RACE CODE
METHODOLOGY AND VERIFICATION

Additional Information in Response to Question 1.

Figure 5.4 - Densification Due to wave Compression + Rarefaction

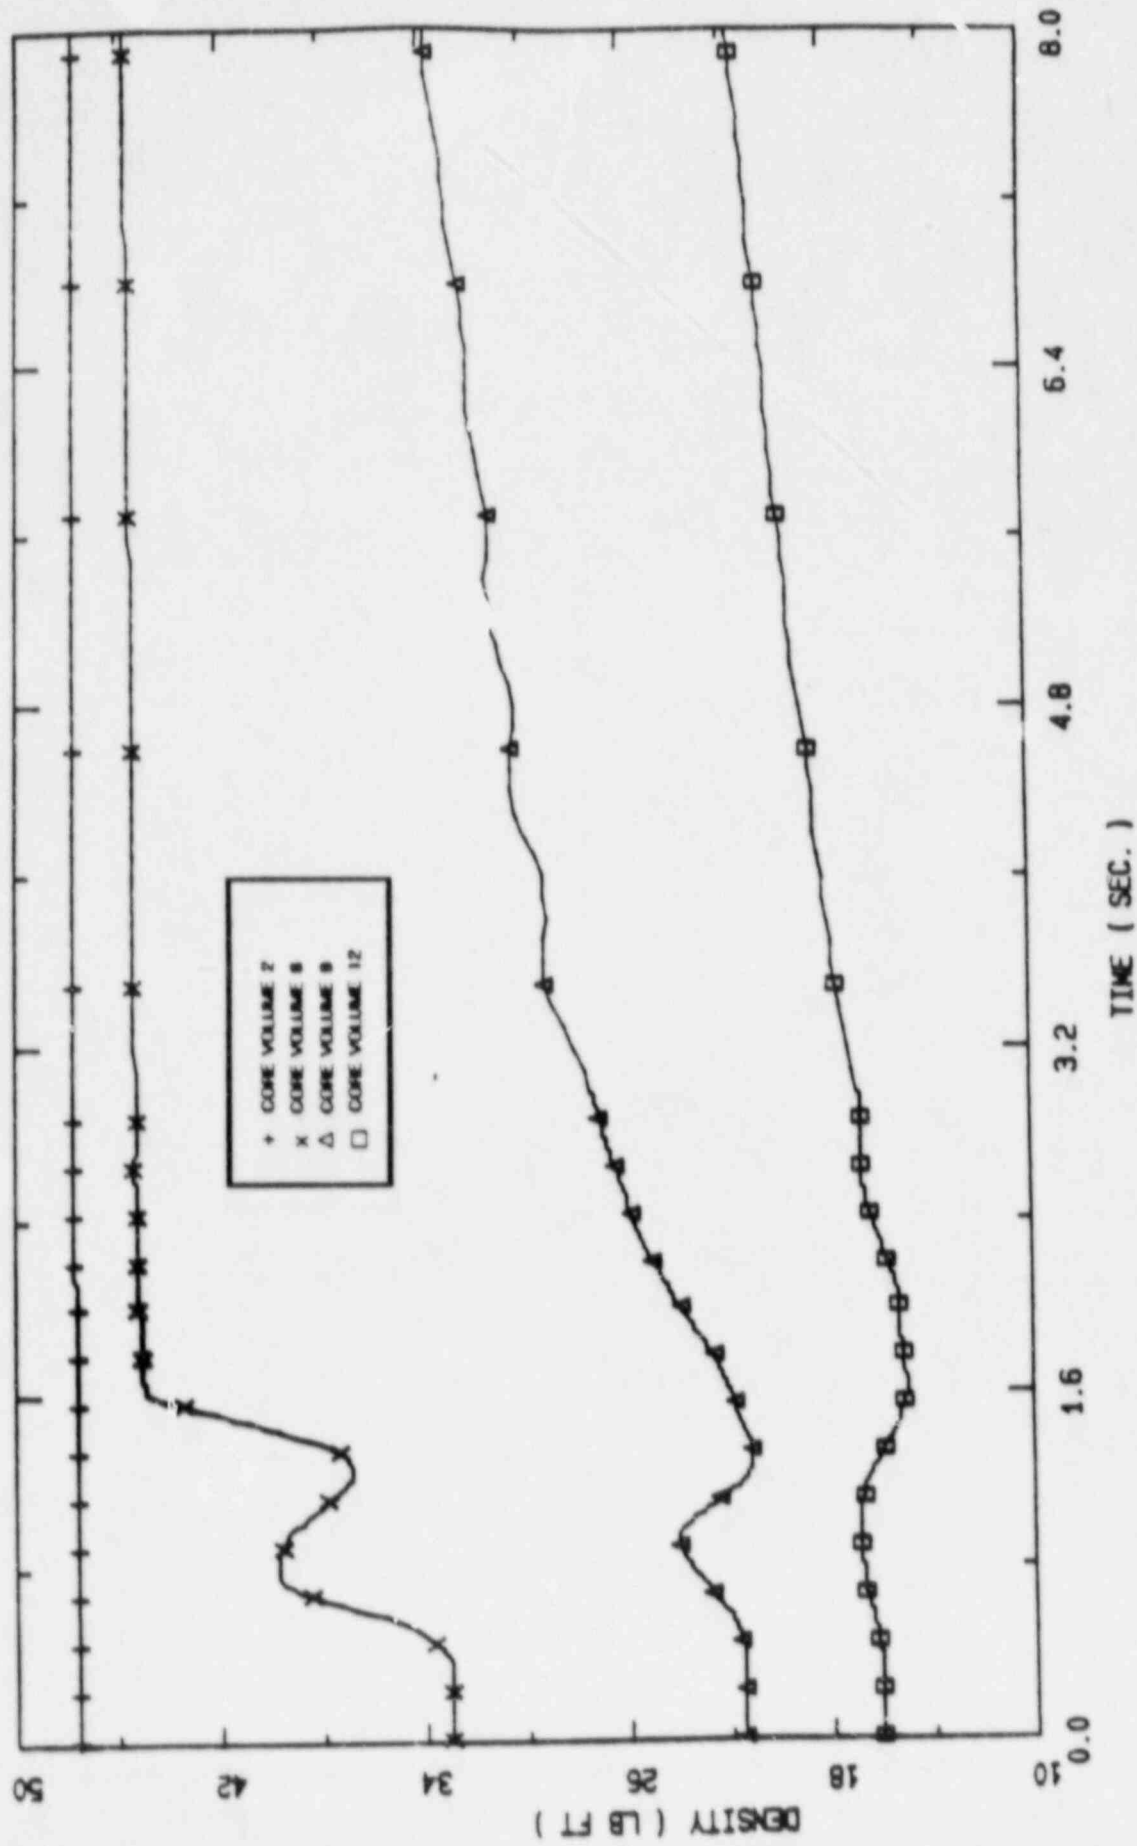
Figure 5.3 shows inlet and exit core flow during the early stages of the transient where an oscillatory component is clearly seen. The increase in inlet flow is due to pressure compression along the downcomer and recirc loop, in the direction of flow, while the decrease in exit flow is due to pressure compression along the separator, standpipe path which is against the direction of flow. The two compression effects are responsible for the fluid densification in the core as seen on average fluid density in different axial locations along the core, in Figure 5.4.

Figure 5.5 - Heat flux at Different Axial nodes

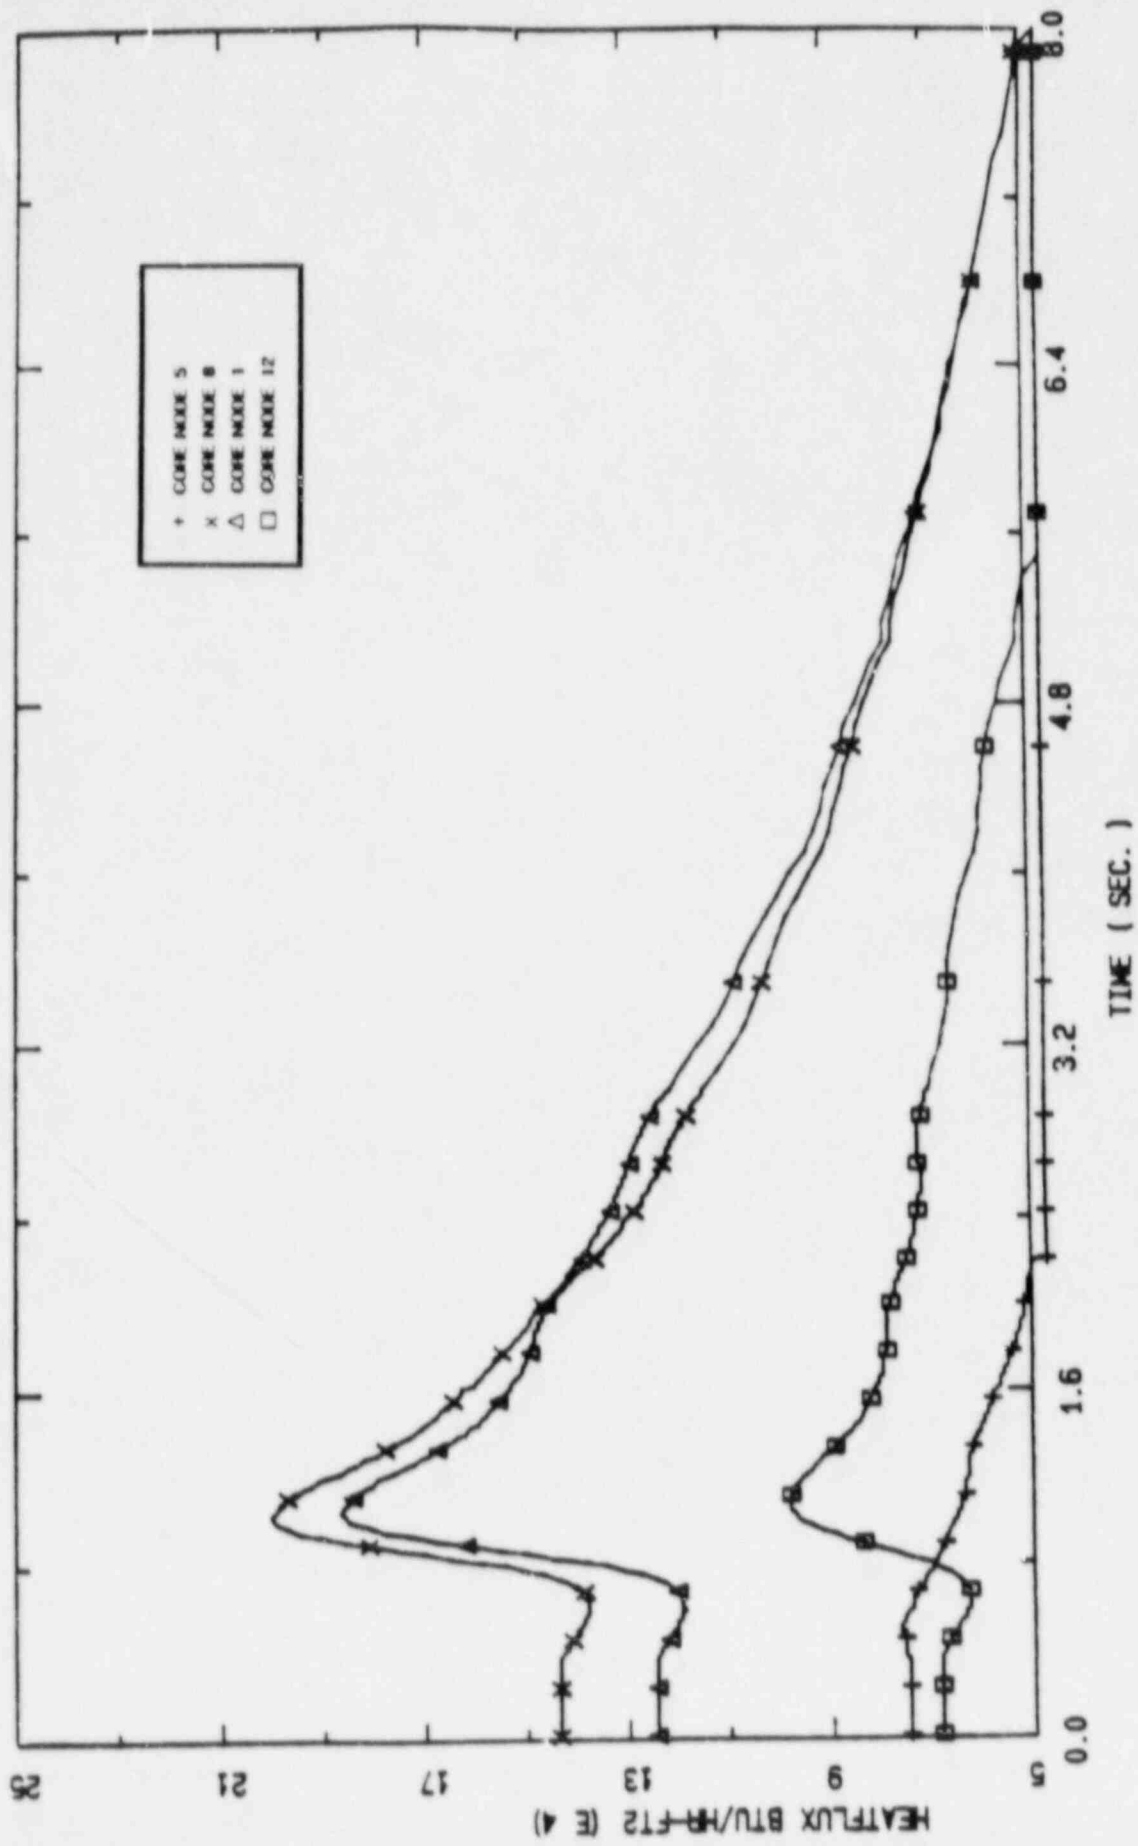
Figure 5.5 shows the heat flux in different axial nodes where the initial drop is due to increase in density.

Figure 5.6 - Non-equilibrium effects on Upper Downcomer

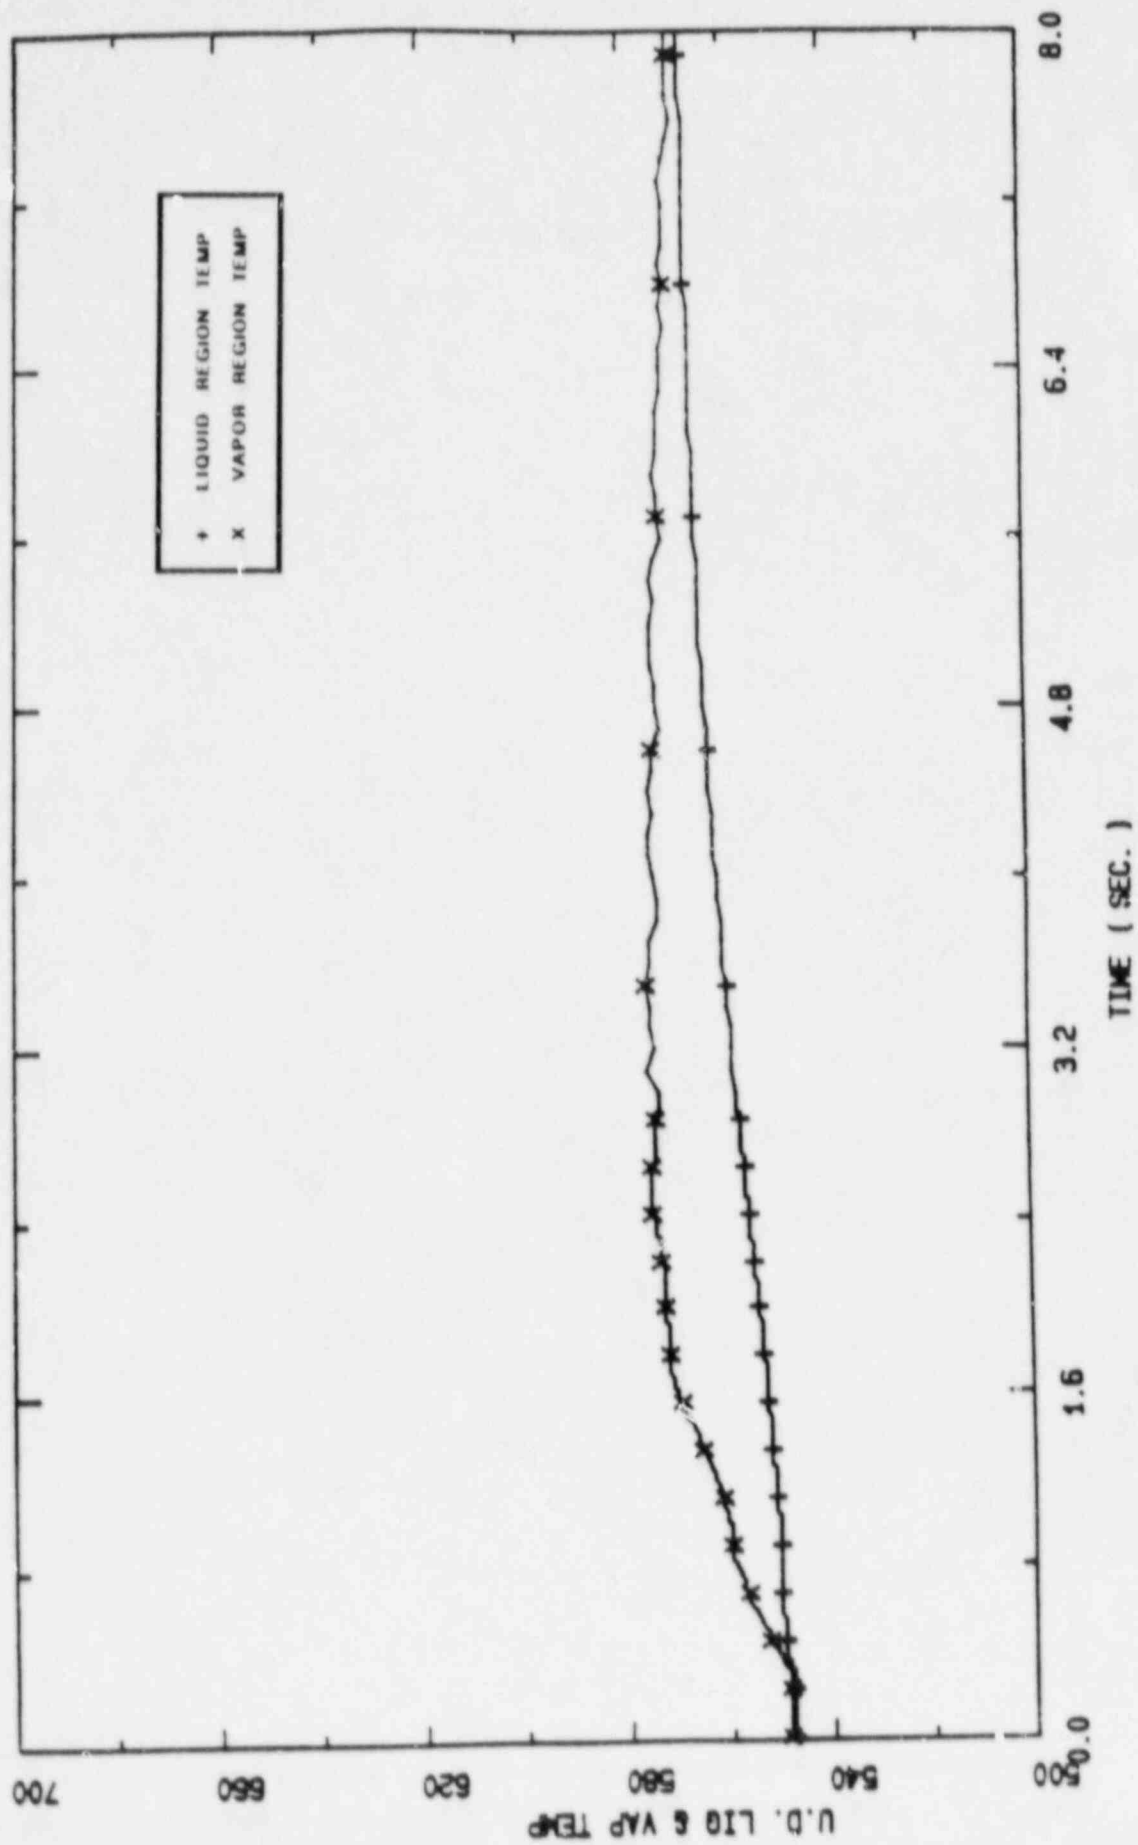
Figure 5.6 is a plot of the liquid and vapor regions temperatures of the upper downcomer where the non equilibrium effect is clearly seen with vapor and liquid temperatures start as equal representing an equilibrium state, but this diverges during the pressurization phase with the vapor becoming superheated as indicated by the increase in temperature. As the pressurization effect runs its course, the temperatures of both phases converge to the equilibrium conditions.

Figure 12.1

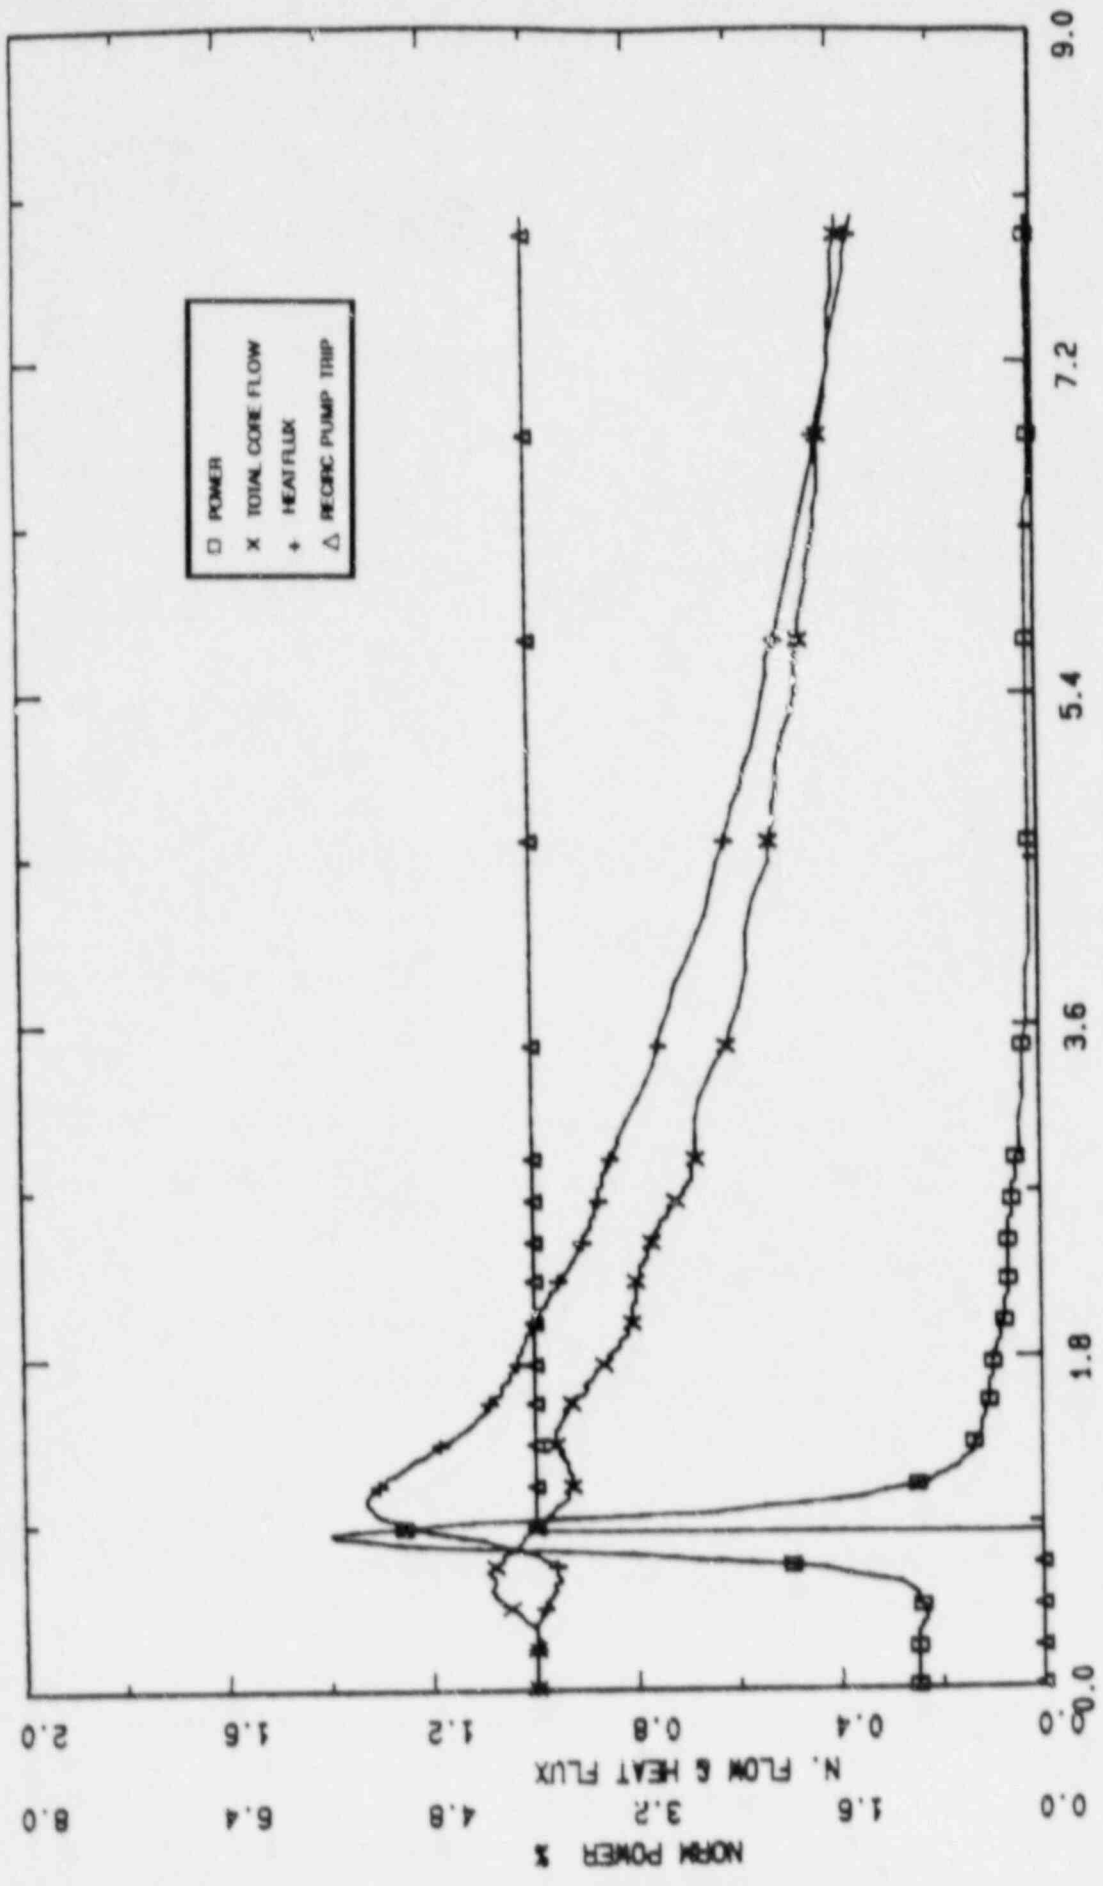
It was quite possible to obtain better coastdown curve, which we did first, but the system inertia had to be adjusted in order to get the correct initial drop in flow immediately after the trip. This resulted in an inertia value which was quite different from the vendor's supplied data (40% more). It was our position that it is more appropriate to use the vendor's documented inertia (design value) which results in a conservative response for ΔCPR . This can be shown by the following argument. In the TTWOP and FWC, peak power occurs prior to the recirc pump trip while peak heat flux will occur after the trip (see Figure 12.1). At the time of peak heat flux, the recirc flow would be less with the faster coastdown and hence a lower CPR. The same would be true for a transient such as a 5 recirculation pump flow. While a faster coastdown would give a faster power decrease, the heat transfer time constant is such that the heat flux would not decay as rapidly as the recirculation flow. This would result in a higher power and lower flow (higher ΔCPR) with a more rapid coastdown than with a slower coastdown.

The use of the non-equilibrium option is limited to pressurization transients only and the pump trip test involved a pressure and power decrease due to pump coastdown and hence this option is usually turned off. During depressurization the code is supposed to switch the calculation scheme in the upper downcomer, where this model is used, to the thermal equilibrium mode when vapor and liquid regions temperatures are equal. However, the RETRAN code cannot do that efficiently and although the code does not fail, it does not produce acceptable response when compared to plant data. This is a known behavior to RETRAN users. Switching this model off in transients where non-equilibrium effects are not present is necessary to correctly calculate the conditions in the upper downcomer. This was evident when the non-equilibrium model was used in the pump trip transient and the resulting incorrect model behavior was observed.
